1992-02-23-0A-*FEA*- Moanalua Earth Movement Area
Drainage & Wall Improvements

NOTICE OF NEGATIVE DECLARATION

CONSTRUCTION OF DRAINAGE AND WALL IMPROVEMENTS

WITHIN THE MOANALUA EARTH MOVEMENT AREA

VERTICAL DRAIN WELL

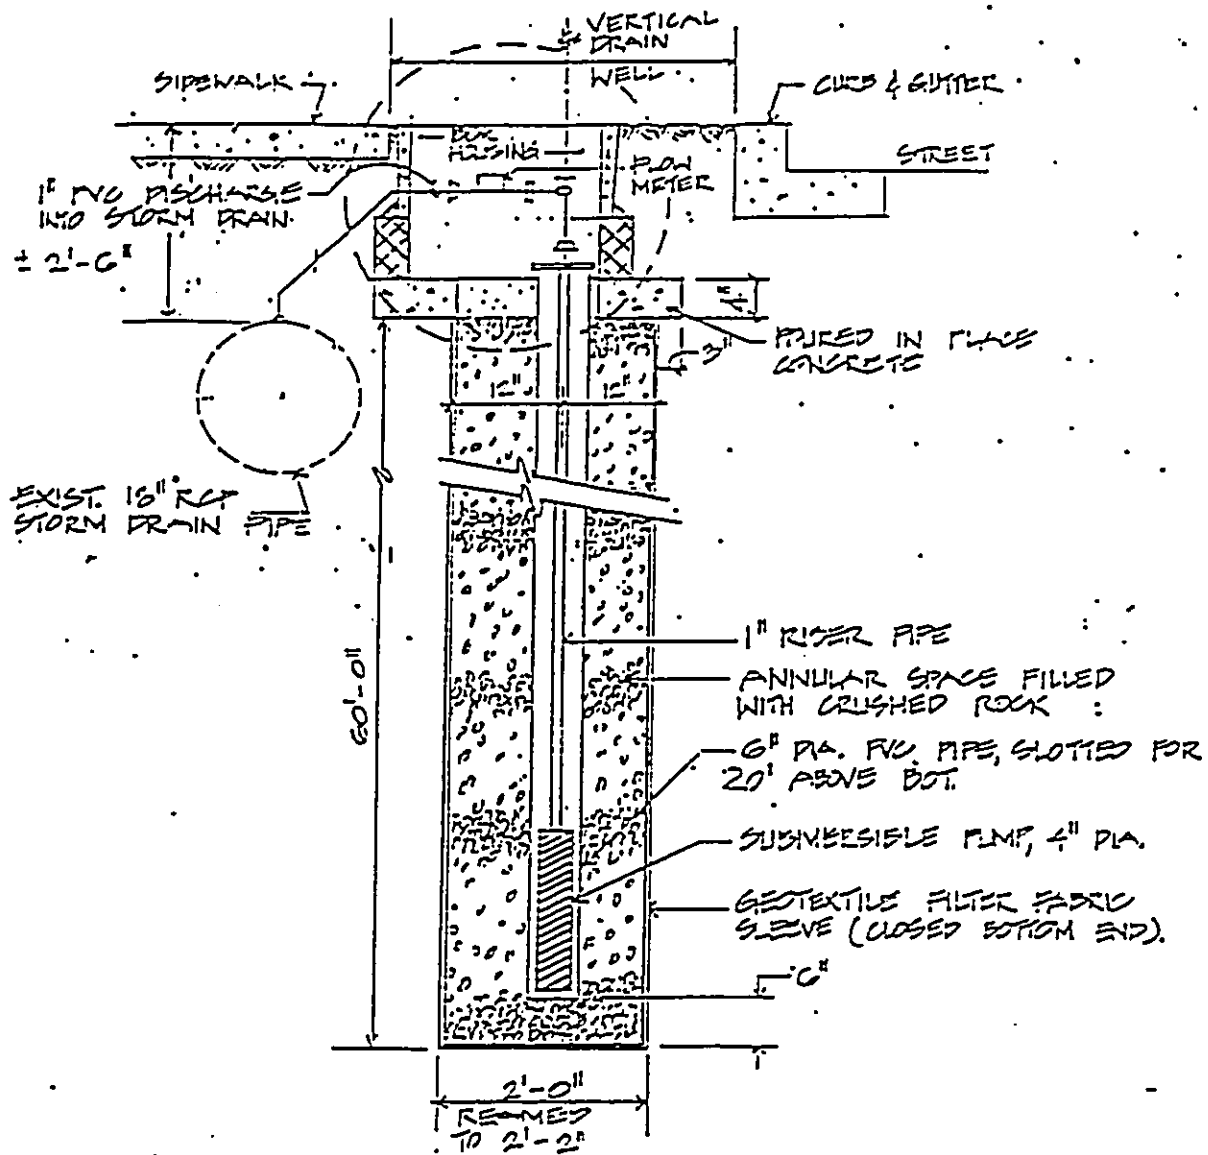
- a. Based on the submitted detail of the typical VD, we question the viability of this design to hold water in order for the submersible pump to pump the infiltrate to the surface.
- b. We question whether or not other subsurface drainage alternatives have been explored to mitigate uphill infiltrate from entering the landslide area. It seems that the use of fifteen (as shown on the plan) VD with submersible pumps and associated equipment is highly energy and maintenance intensive over a time period which has not been specified and at an operational cost which has not been projected.

- 3a. *Based on the submittal detail of the typical vertical drain, we question the viability of this design to hold water in order for the submersible pump to pump the infiltrate to the surface.*

The vertical drains are to be installed in colluvium for most of the depths involved with perhaps several penetrating into the underlying bedrock basalt. The colluvium is composed of pebbles, cobbles, and boulders in a silty clay

matrix. Some strata are more permeable and act as aquifers but the crushed rock in the vertical drain is more permeable by several orders of magnitude and will collect subsurface ground water which is expected to be deflected from its existing drainage path into the drain. The volume of flow is not expected to be high, but the important result will be a reorientation of the subsurface ground water seepage flow toward the drains and interception of most of the water now entering the upper portion of the landslide.

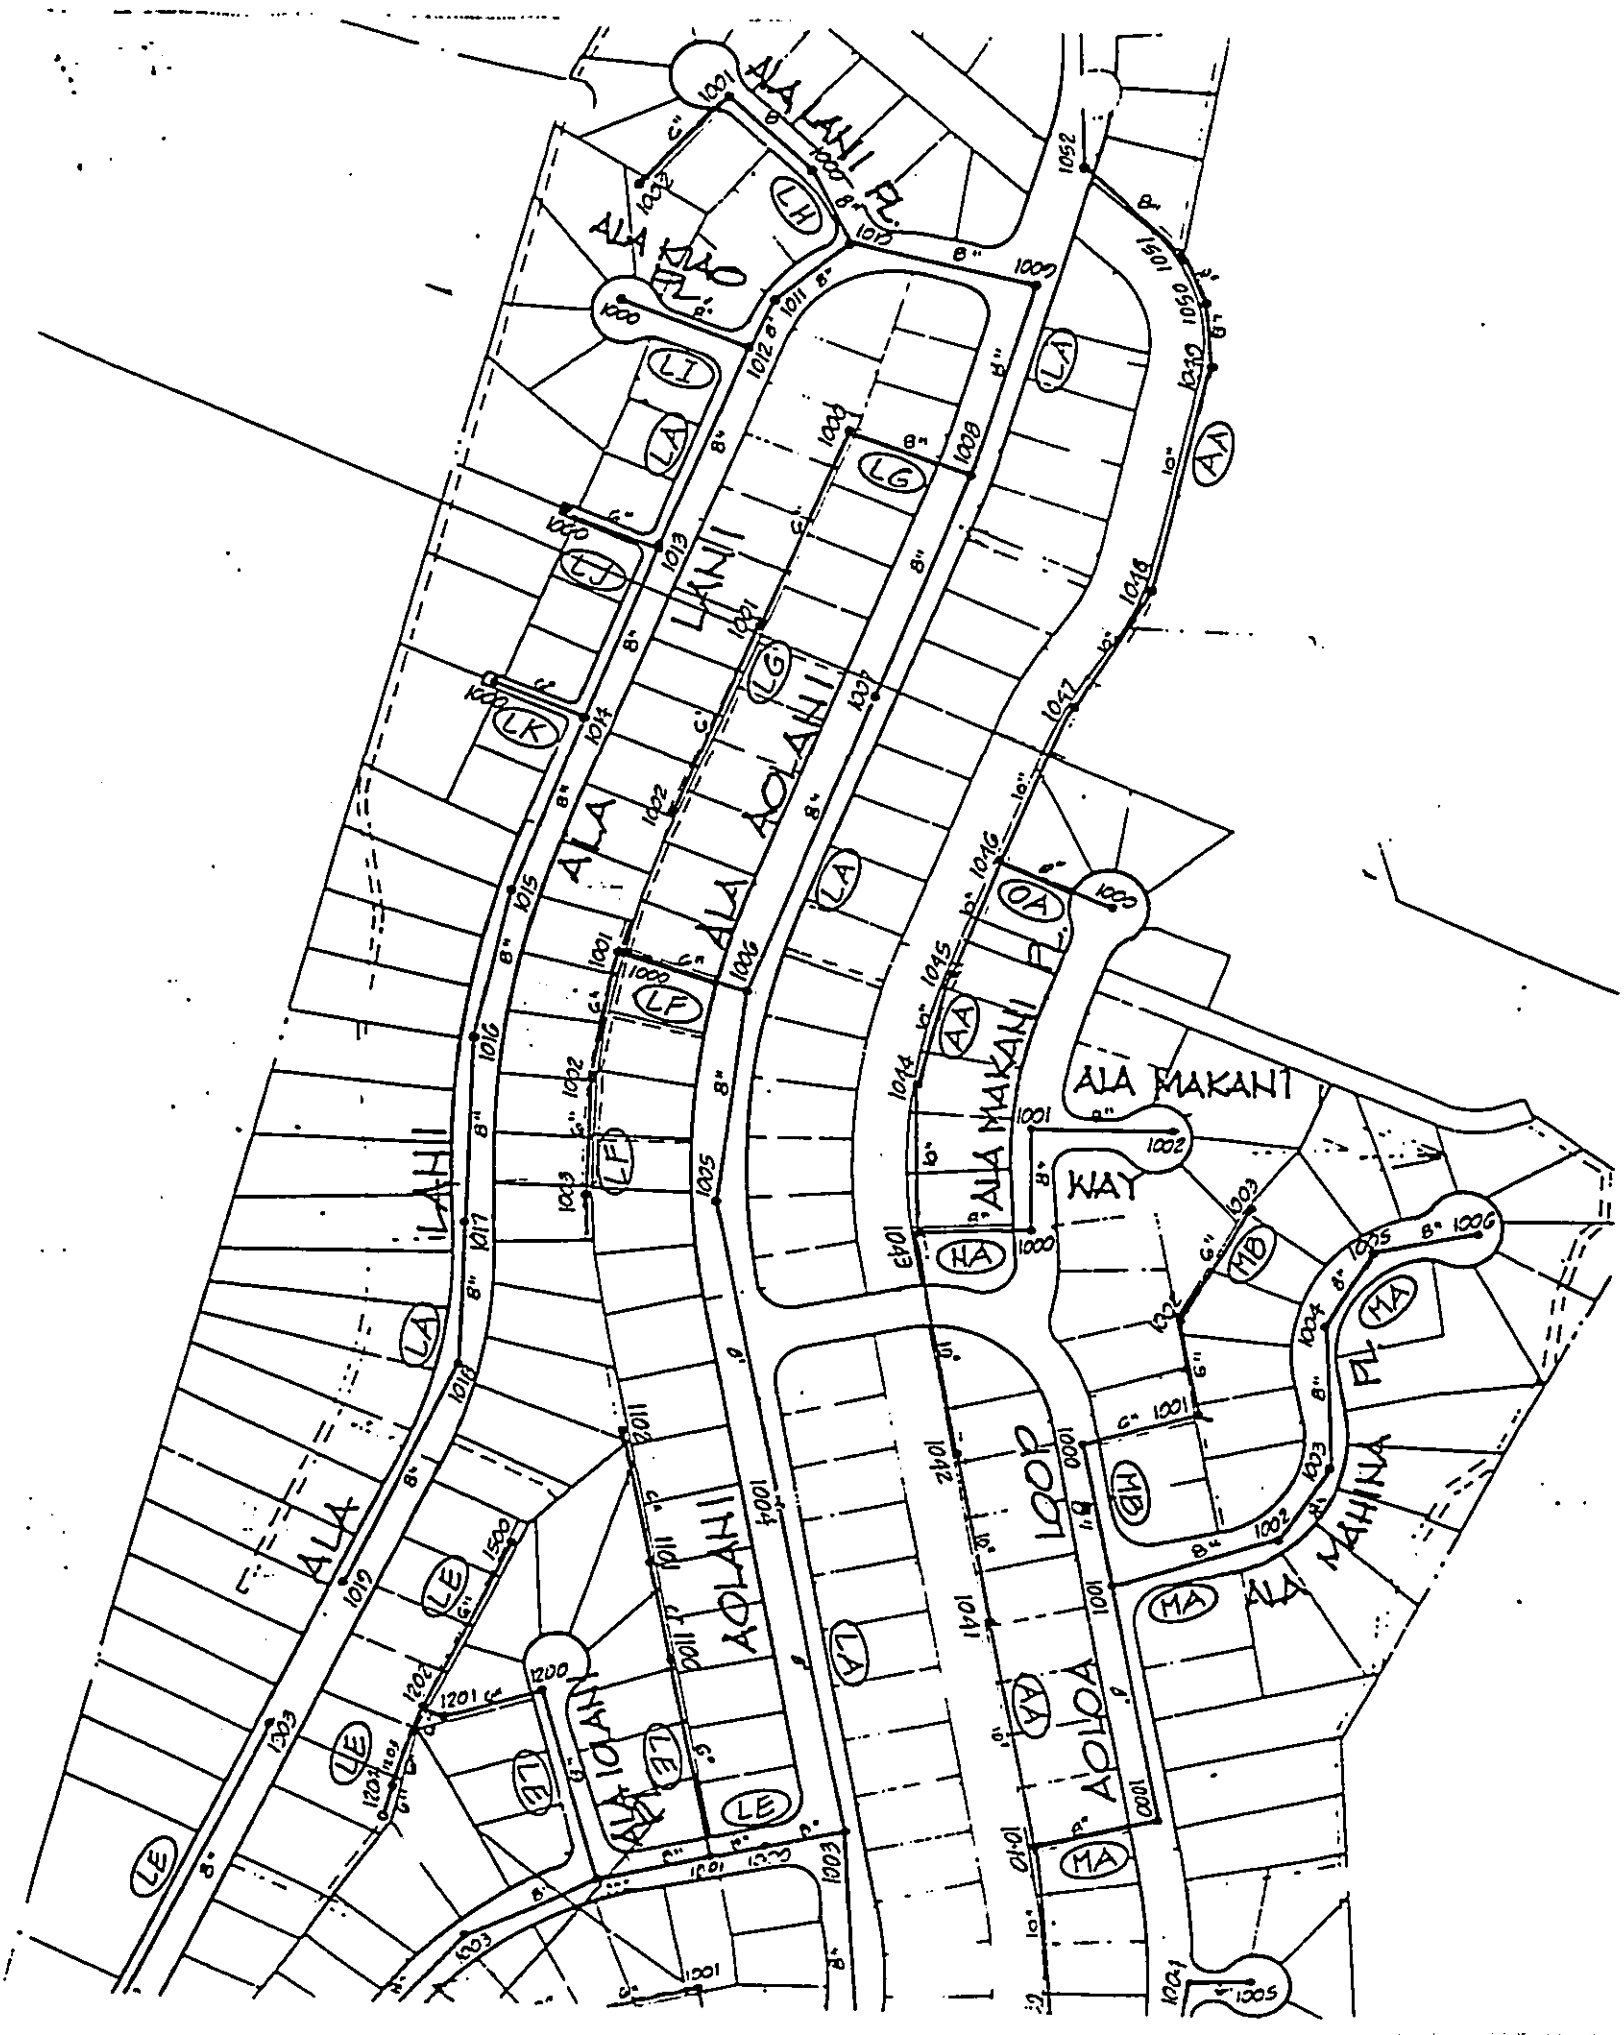
Please be informed that there are existing municipal sewer manholes and 6 and 8-inch sewer lines in the roadways and sewer easements within the subject earth movement area (see attached map). Construction plans for the drainage and wall improvements must be submitted to the Division of Wastewater Management for review and approval.
